# UNITED STATES PATENT AND TRADEMARK OFFICE

10/576,935

<b>Office Action Summary</b>	<b>Application No.</b> 10/576,935	<b>Applicant(s)</b> DENEUVILLERS ET AL.	
	<b>Examiner</b> ELANA B. FISHER	<b>Art Unit</b> 3733

## **DETAILED ACTION**

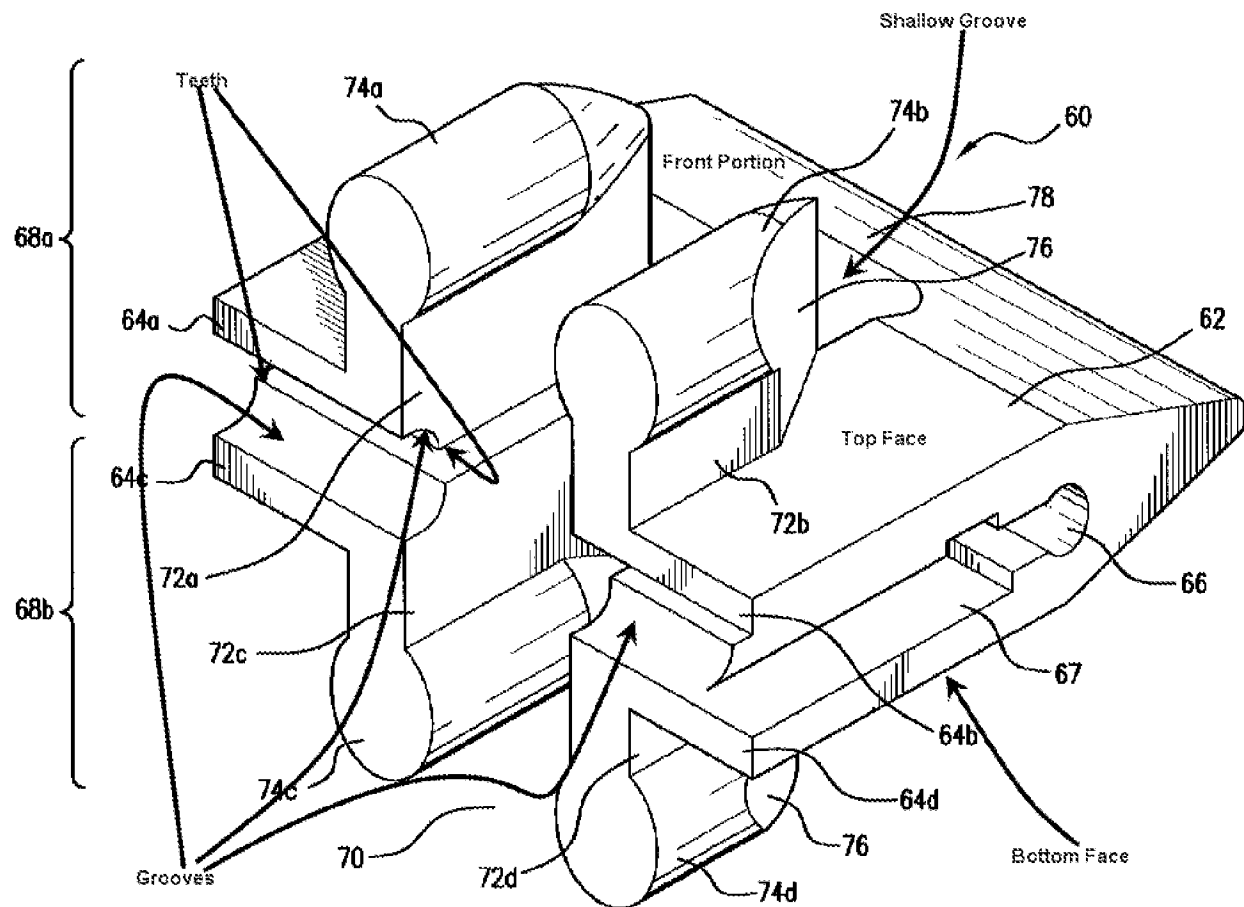
Castro discloses an intervertebral support (FIG 5) comprising an anterior portion (64a-64d) having a substantially planar face (FIG 5), a posterior portion (62) for dampening movement between adjacent vertebrae comprising a retaining member (72a-72d), the posterior portion having a front portion (see diagram provided) and top and bottom faces (see diagram provided). The retaining member (72a-72d) further comprises transverse projections/shoulders with symmetrically-opposite projecting bulges (74a-74c) that are set back from the anterior portion and that extend from the top and bottom faces (FIG 5) of the posterior portion (62), such that the bottom face bears on a top portion of a process at a bottom of the space filled with the support; and the planar face of the anterior portion (64a-64d) has a smaller surface area than The front portion (see diagram provided) of the posterior portion (62).

The anterior portion (64a-64d) is additionally provided with grooves (see diagram provided) between the planar face (FIG 5) and the front portion of the posterior portion. The posterior portion (62) is a tapering shape, thereby tapering in a posterior direction and flaring towards the anterior portion (FIG 5), such that there can be a freedom of movement between the top face and laminae located above the region filled with the support. Additionally, a core of the posterior portion (62) has a recess (66) enabling flexibility of the support to be increased. The core carries teeth (see diagram provided) spaced apart by furrows and opposed to each other in pairs on top and bottom faces of the

posterior portion. The top portion face of the support (see diagram provided) additionally comprises a shallow groove (see diagram provided) extending lengthwise in its middle.

Castro discloses a support according to claim 22 above and additionally discloses that the posterior portion (62) is prismatic in shape (FIG 5) and of a height that corresponds to a spacing between adjacent vertebrae, however fails to disclose that the top face is triangular in shape. It would have been an obvious matter of design choice to one skilled in the art at the time the invention was made to construct the top face of the posterior portion in the shape of a triangle, since applicant has not disclosed that such solve any stated problem or is anything more than one of numerous shapes or configurations a person ordinary skill in the art would find obvious for the purpose of providing the top face of the posterior portion. *In re Dailey and Eilers*, 149 USPQ 47 (1966).
